AGENDA
BIG LAKE PLANNING COMMISSION MEETING
COUNCIL CHAMBERS

July 6, 2026
6:00 p.m.

Prepared By: Kendra Lindahl, AICP Consulting Planner	Meeting Date: 7/6/2026	Item No. Click or tap here to enter text.
Item Description: *Public Hearing* - Comprehensive Plan Amendment, Zoning Text and Map Amendment, Development Stage Planned Unit Development, and a Preliminary Plat for "Preusse Lake Preserves" Subdivision on Outlot A of Big Lake Marketplace North Addition	Reviewed By: Hanna Klimmek, City Administrator	
	Reviewed By: Marie Popp, Community Development Director/EDA Executive Director

The Planning Commission is asked to make a motion recommending approval or denial of the "Preusse Lake Preserves" Development Application for a Comprehensive Plan Amendment, Zoning Text and Map Amendment, Development Stage Planned Unit Development, and a Preliminary Plat for a 31-lot subdivision on Outlot A of Big Lake Marketplace North Addition.

SANITARY SEWER & WATERMAIN PLAN
PREUSSE LAKE PRESERVE
BK LAND DEVELOPMENT

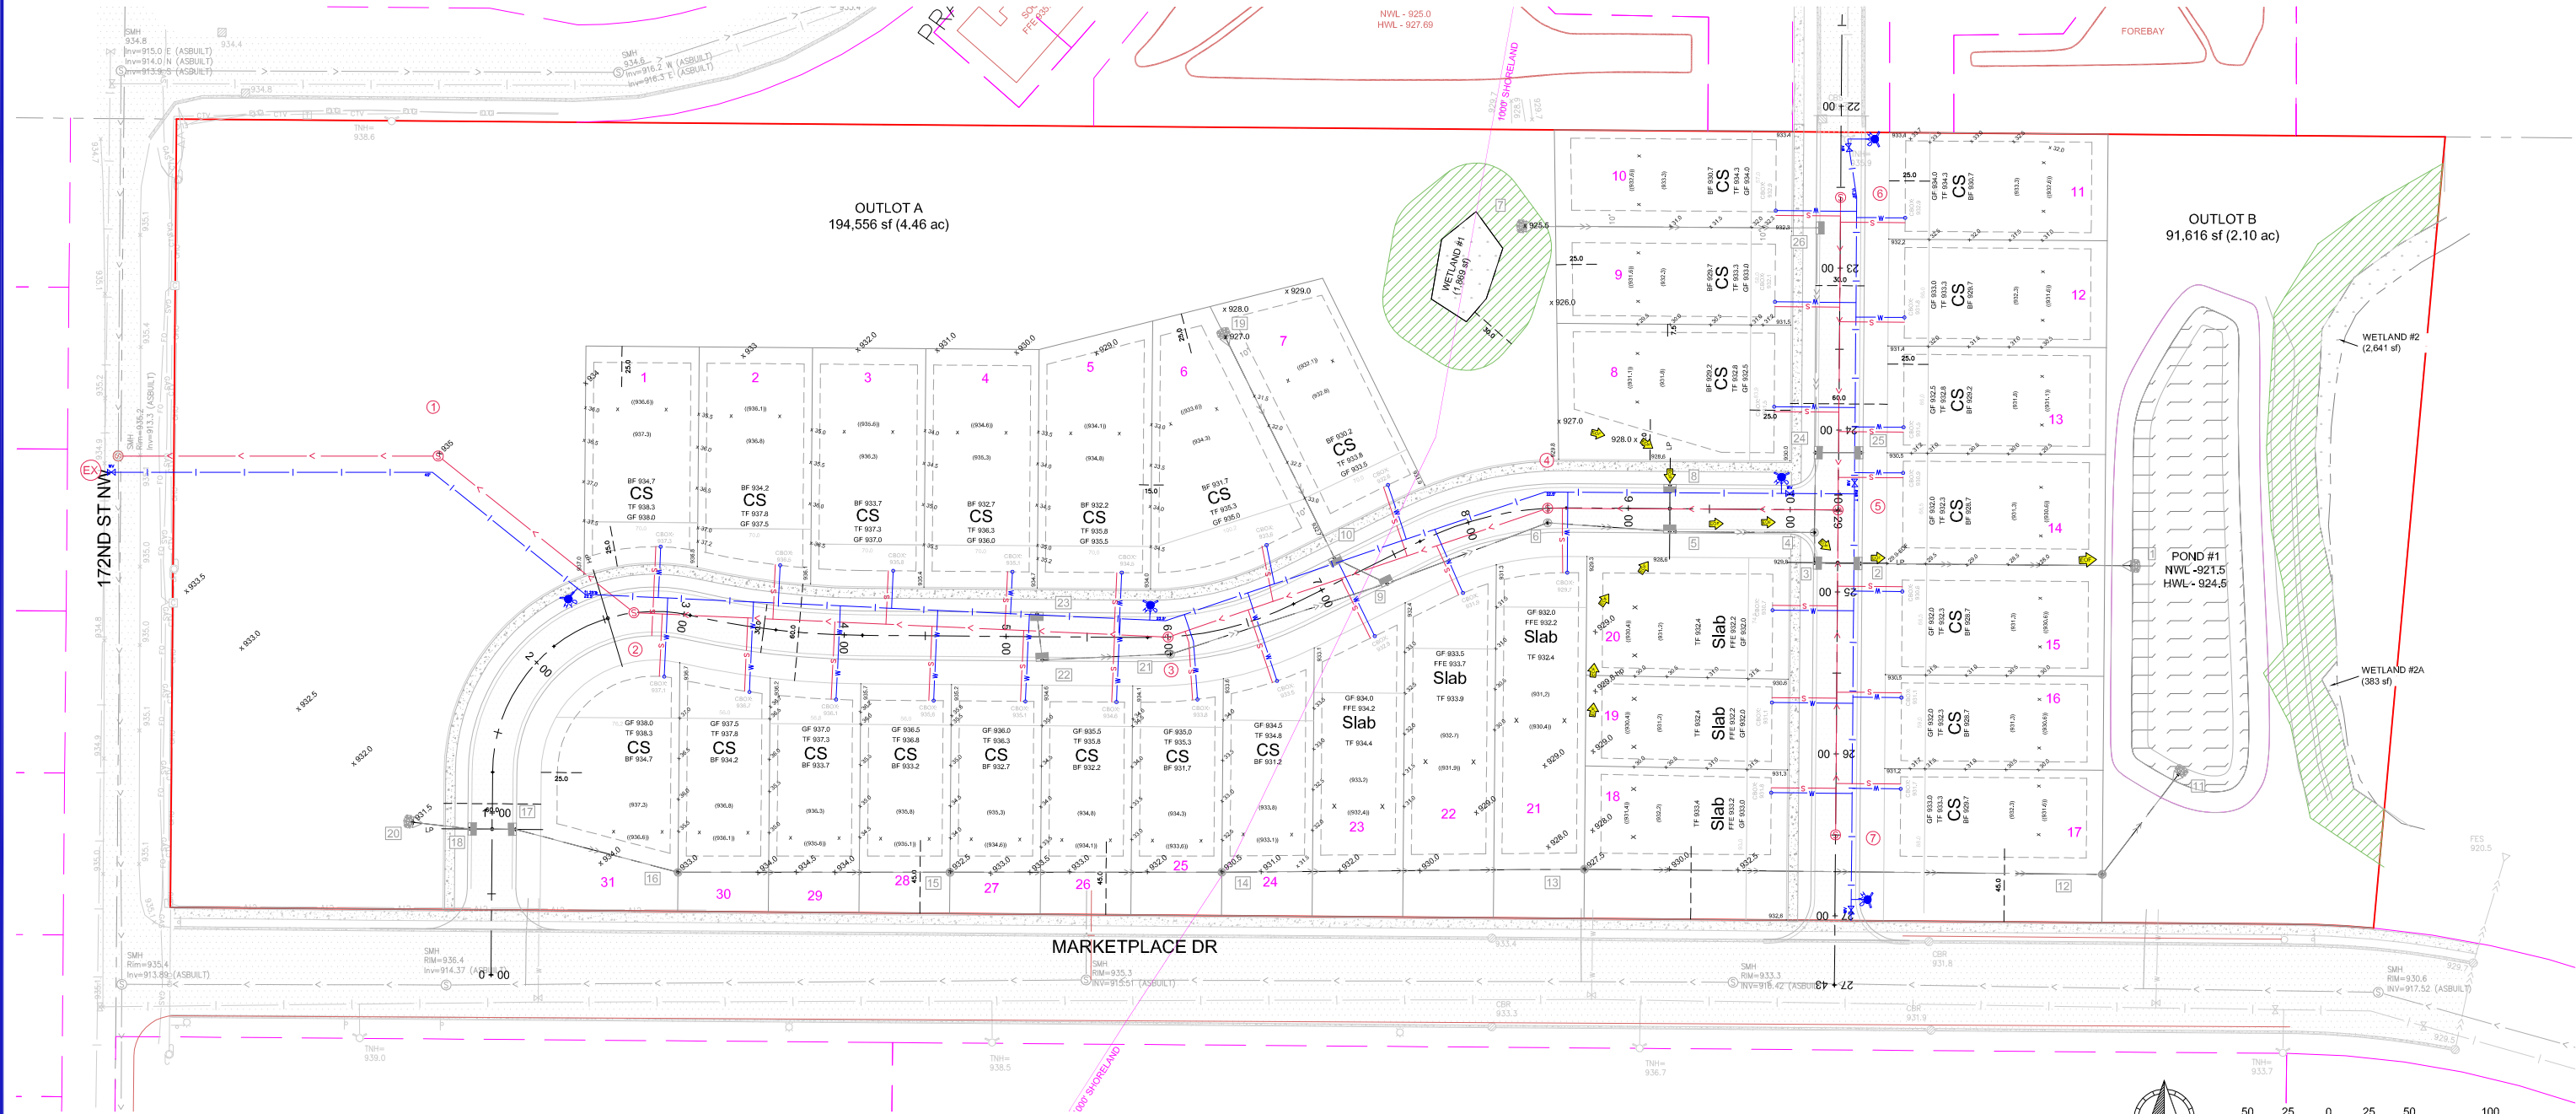
The City Water/Wastewater Superintendent has reviewed the plans and prefers that the watermain loop back to Marketplace Drive.

LANDSCAPE PLAN

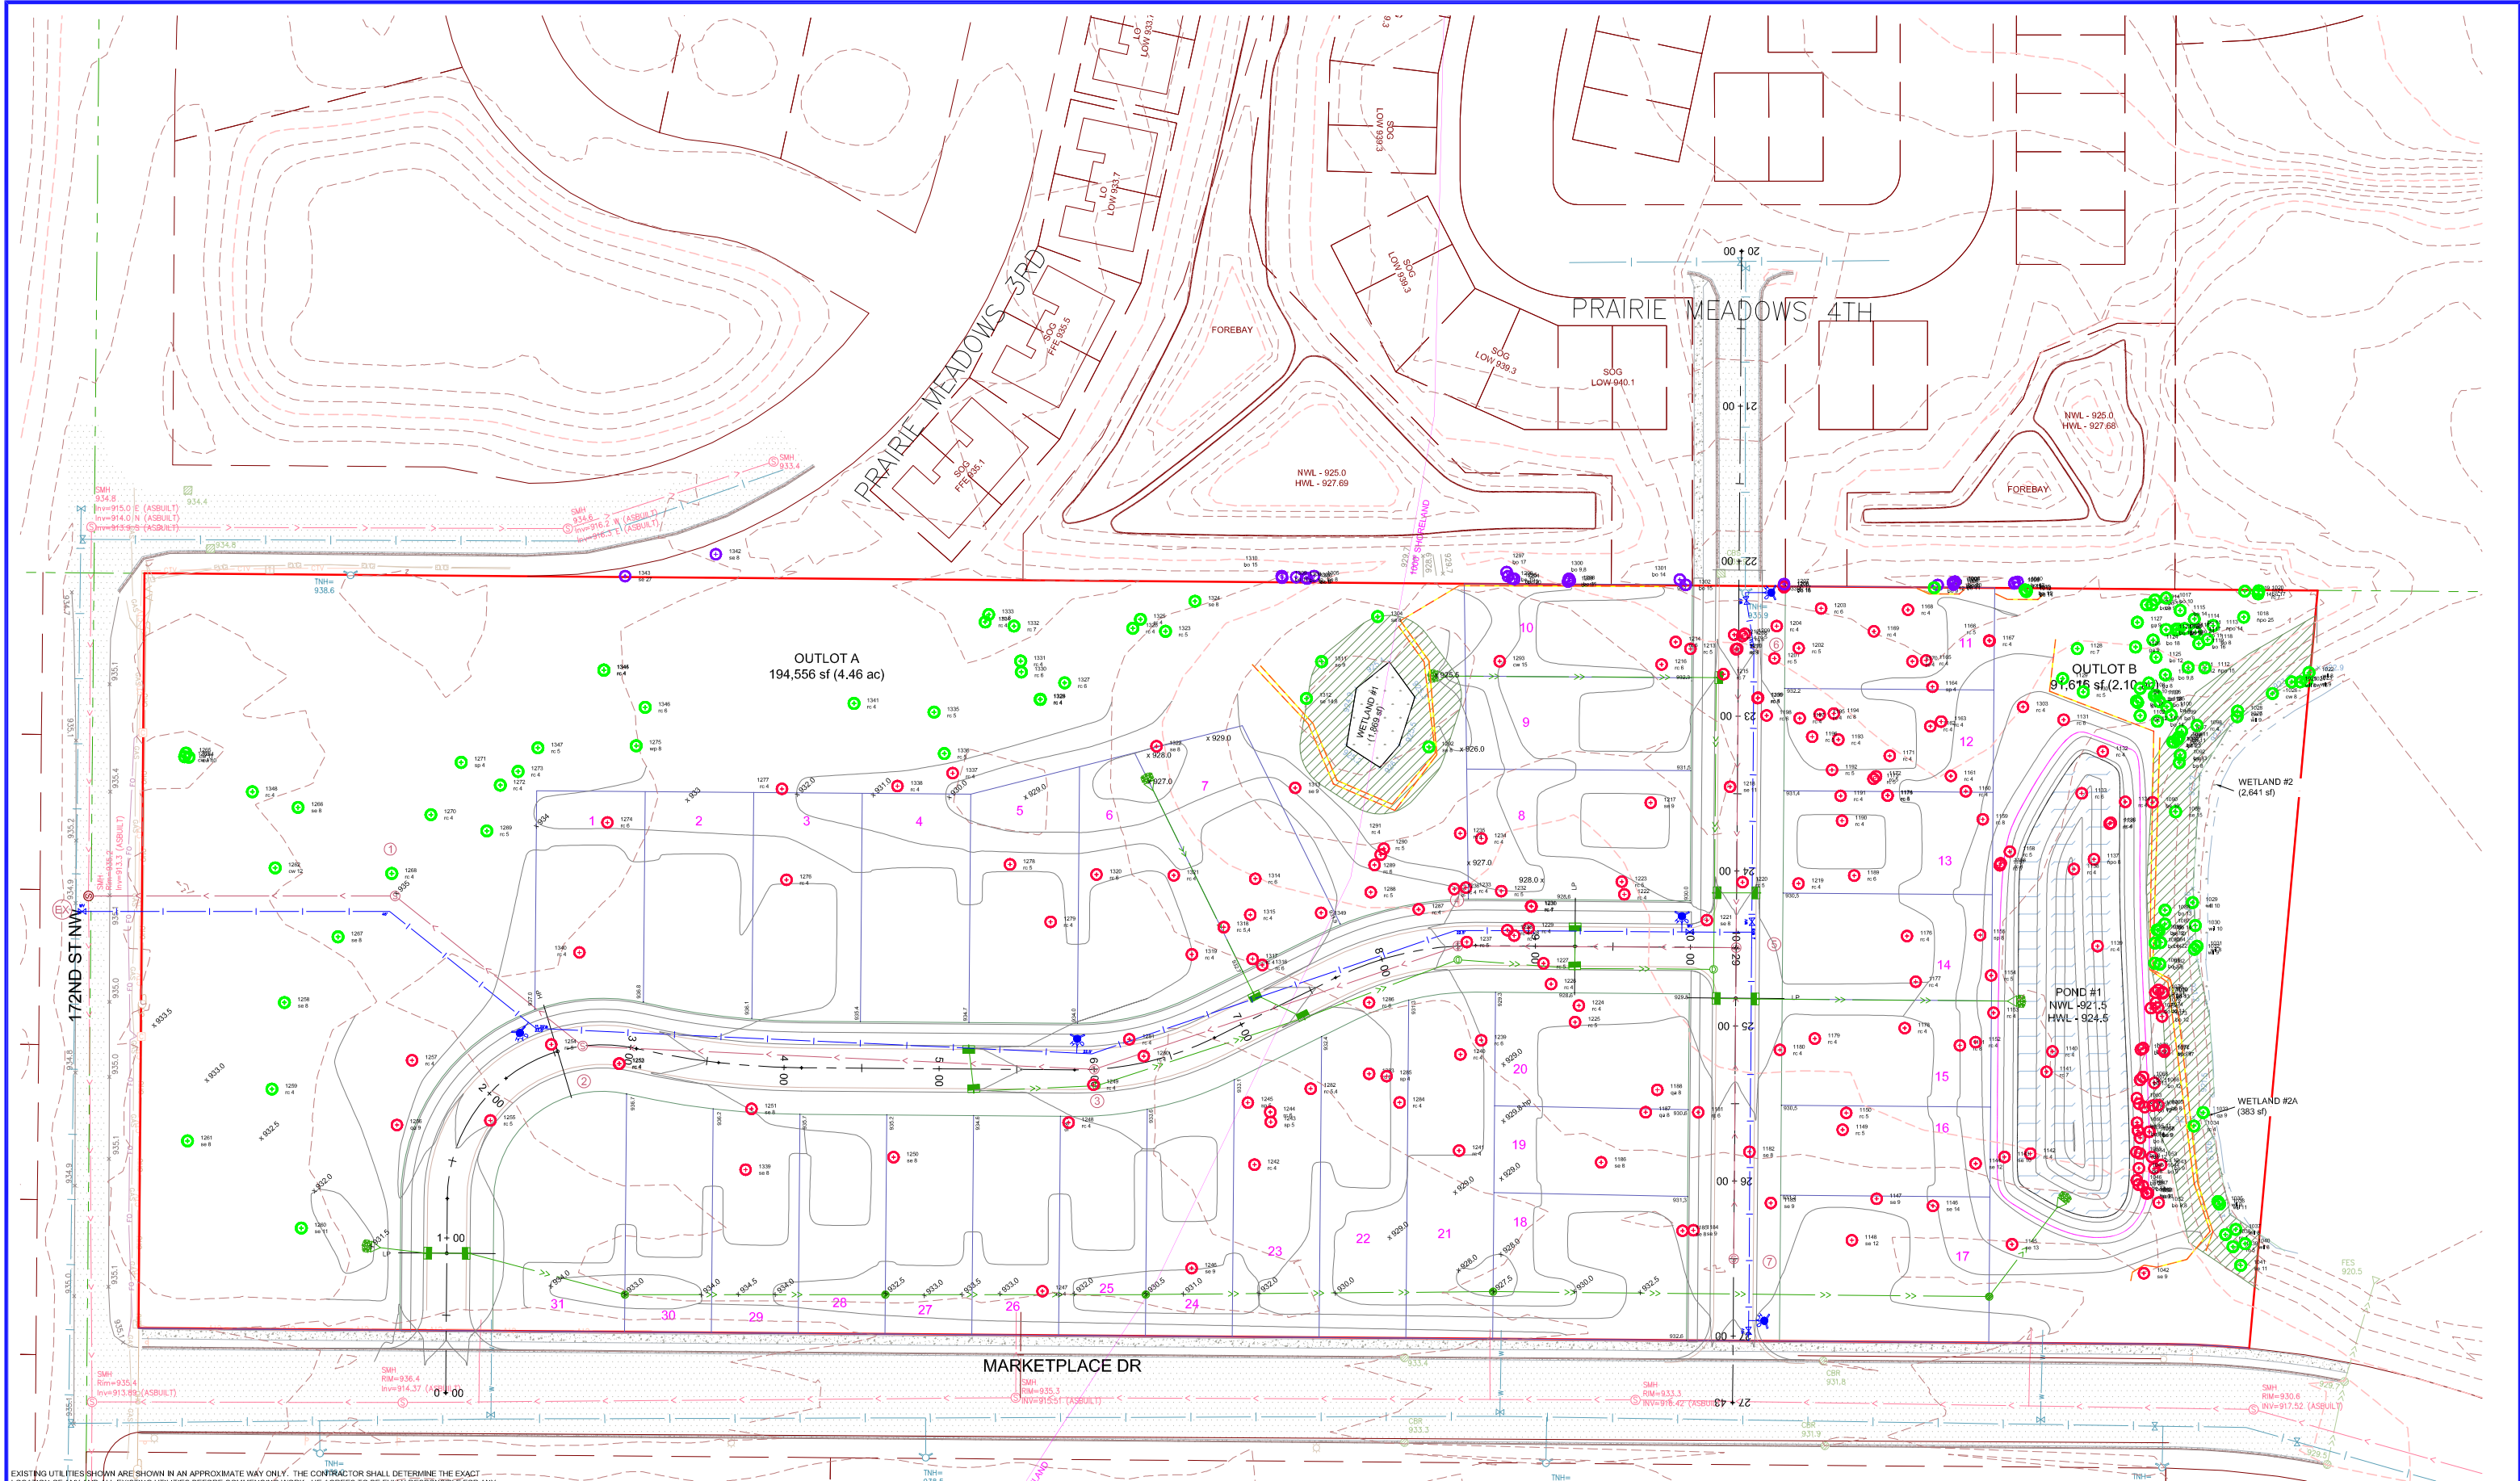
The landscape plan shows two trees per front yard of each home and additional buffering along the rear yards of homes that abut Marketplace Drive. In total they show 109 trees to be planted. However, the tree replacement plus the two trees in each front yard would require 116 trees. The plans should be revised to show a minimum of 116 trees on site.

Additionally, the trees and plantings along the rear yards of homes abutting Marketplace Drive are required to follow the Buffer Yard design standards found in Section 1006.06 Subd. 4.3(b). These requirements include spacing materials that the applicant has not demonstrated compliance with. The plans will need to be adjusted to show compliance with spacing requirements of the buffer yard. This is a range of 4 to 40 feet on center for deciduous trees and three to 15 feet on center for conifers. Compliance with these standards would likely result in the development meeting the tree replacement standards noted above.

15. The applicant must revise the landscape plan to show compliance with buffer yard spacing and show the required number of trees (116). This includes adding at least 7 additional trees to the current plans.

TREE SURVEY/PRESERVATION PLAN
PREUSSE LAKE PRESERVE
BK LAND DEVELOPMENT

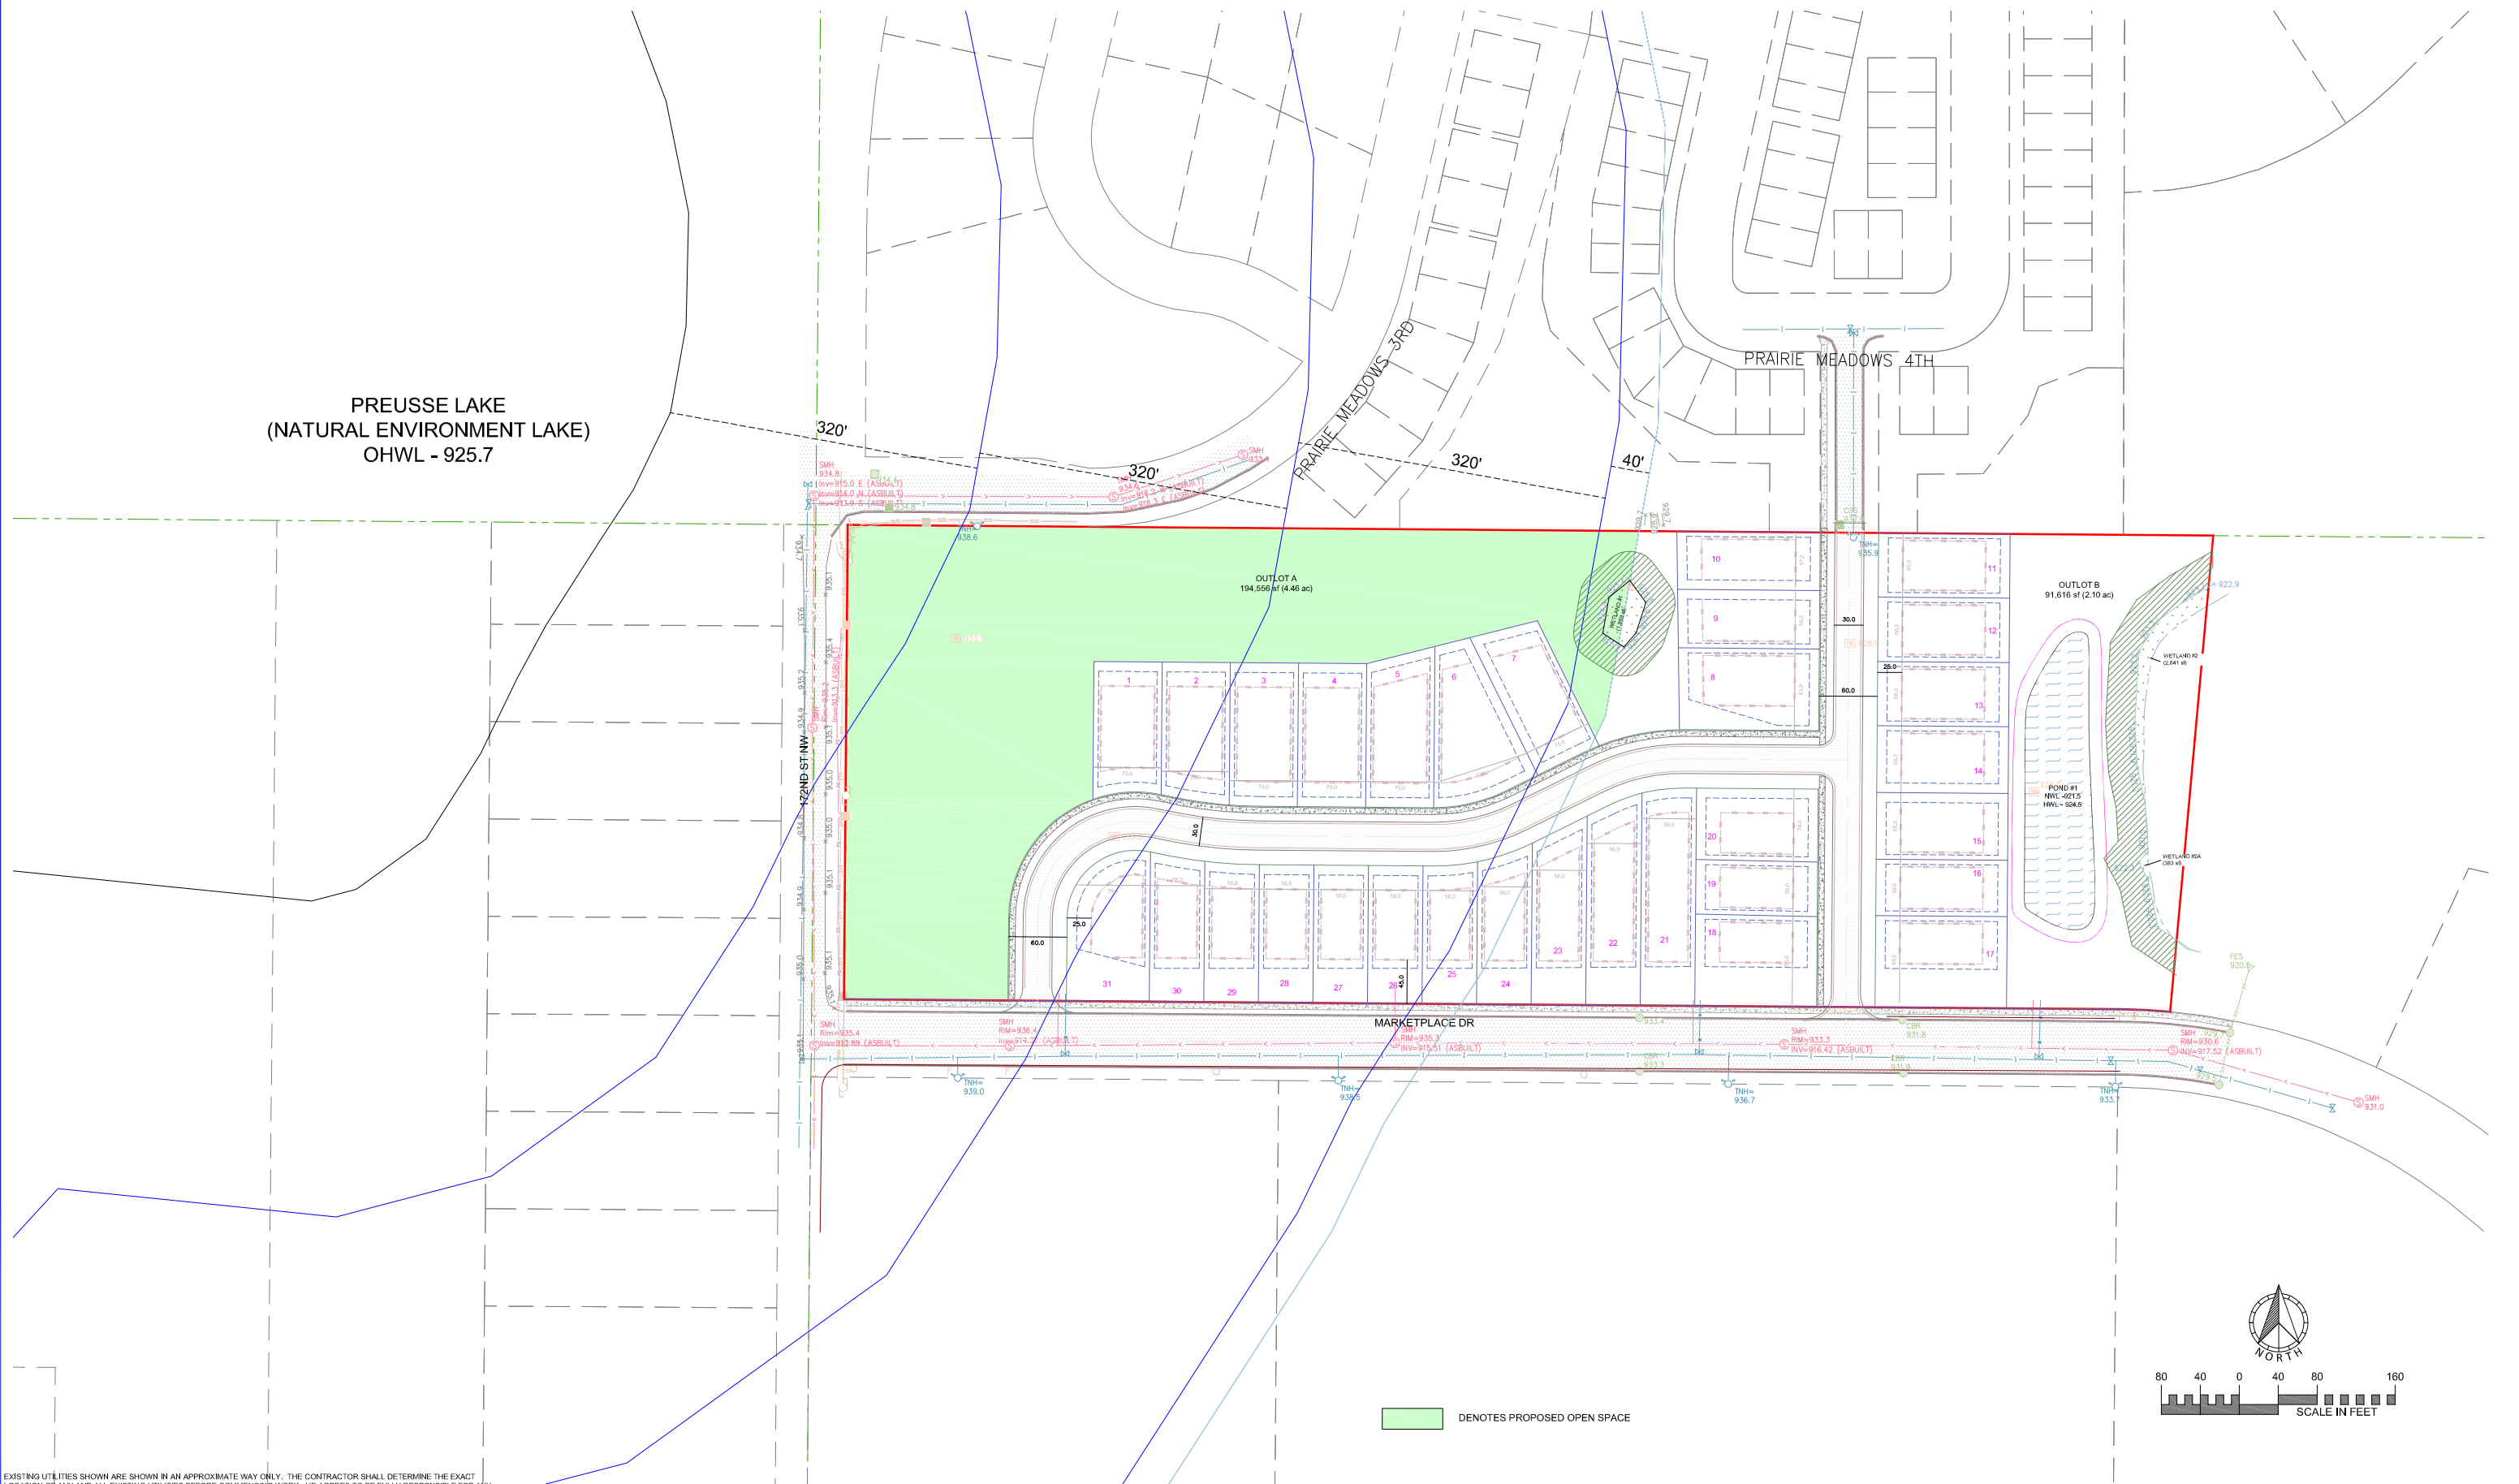
Section 1107.11 requires preservation of a minimum of 40% of the existing significant trees. The plans show 62% removal, and so they are subject to replacement standards for the trees over 40%. Specifically, they are removing 200 of the 322 trees on site (62%) trees and will need to plant 134 caliber inches, or 54 trees to meet the requirements for tree replacement.

Staff has requested the tree preservations tables in a more usable format to confirm that the replacements required are counted correctly, including counting the caliber inches of removed trees based on smallest trees removed first. It does not appear that the preparation of this plan and analysis will make a significant difference to the proposed preservation plan, however the condition has been added to provide these materials for a full analysis prior to approval of the final PUD plan. Overall, the plans generally comply and maintains a large number of trees, while replacing trees as required by Code.

14. The applicant must provide the Tree Preservation Plan table in an Excel format to demonstrate full compliance with Section 1107.11 on how to count caliber inches for replacement trees.
